Aquifer Mapping &
Groundwater Protection Zone

RE: Accuracy of Aquifer Mapping and Related
Town of Ramapo Groundwater Protection Zone
Map Associated with the Proposed Patrick Farm
Development Area
Town of Ramapo, New York

**COMPARISON OF NEW YORK STATE AND
TOWN OF RAMAPO AQUIFER MAPPING**

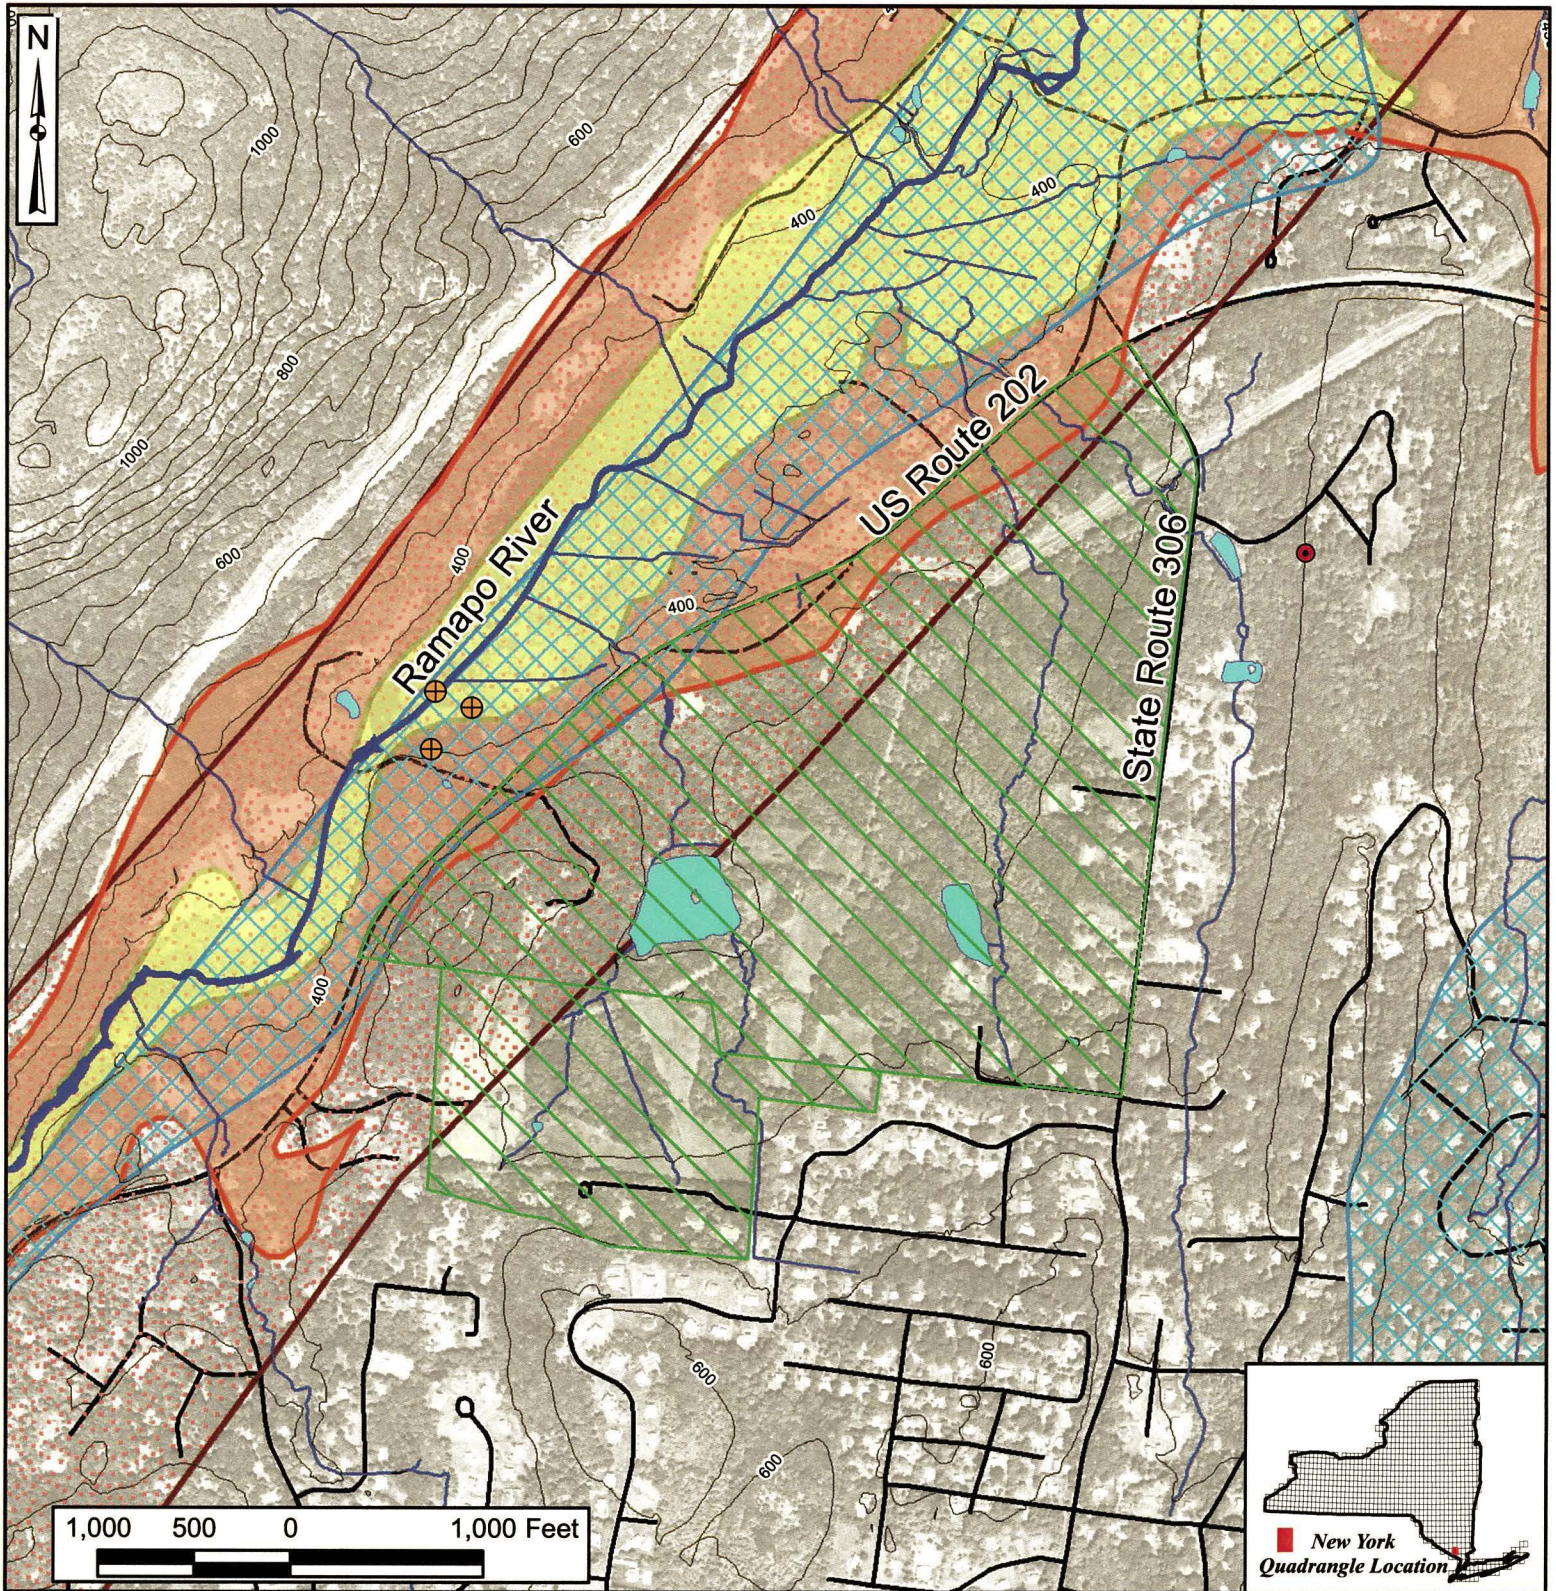
A GIS-based map of the aquifer and comprising deposits, as well as the corresponding area of adjoining high permeability material (kame and kame terrace deposits), as presented in the respective references is provided as Figure 1 (attached). Based on the respective delineations, none of the aquifer materials as identified by the USGS occurs within the proposed Development area, and only a very limited portion of the adjoining high permeability material occurs locally within the western boundary of the Site, proximal to the west side of Route 202. As such, the Site does not overlie the Mahwah River Valley aquifer as identified by the USGS and NYSDOH. The attached Figure 1 map also shows the extent of the Aquifer and Groundwater Protection Zone in the proposed Development area as presented by Chapter 96.

A comparison between the respective delineations indicates that the Groundwater Protection Zone roughly corresponds to an area consisting of portions of both aquifer and high permeability material as identified by the USGS. This suggests that the Chapter 96 Groundwater Protection Zone is intended to represent the aquifer underlying the local portion of the Mahwah River valley. From this comparison it is also apparent that locally the Groundwater Protection Zone coincides mainly with the USGS high permeability materials area, and not the USGS aquifer area. As such, it is questionable as to what the area identified as "Aquifer" by Chapter 96 actually represents. Furthermore, the portion of the Chapter 96 Aquifer mapped as occurring in the proposed Development area significantly exceeds the extent mapped

as aquifer by the respective source references (USGS). As such, it appears that this excess represents an error and/or GIS based exaggeration associated with the Protection Zone Map for Chapter 96 relative to the proposed Development area. Therefore, based on the contradictions between the technical source data and the FPCA mapping, the mapping basis for the applicability of Chapter 96 to the proposed Development is not hydrogeologically supported. As such, it does not appear the Site occurs within the boundaries of the Mahwah River valley aquifer as mapped by the technical resources directly responsible for the hydrogeologic mapping in the proposed Development area.
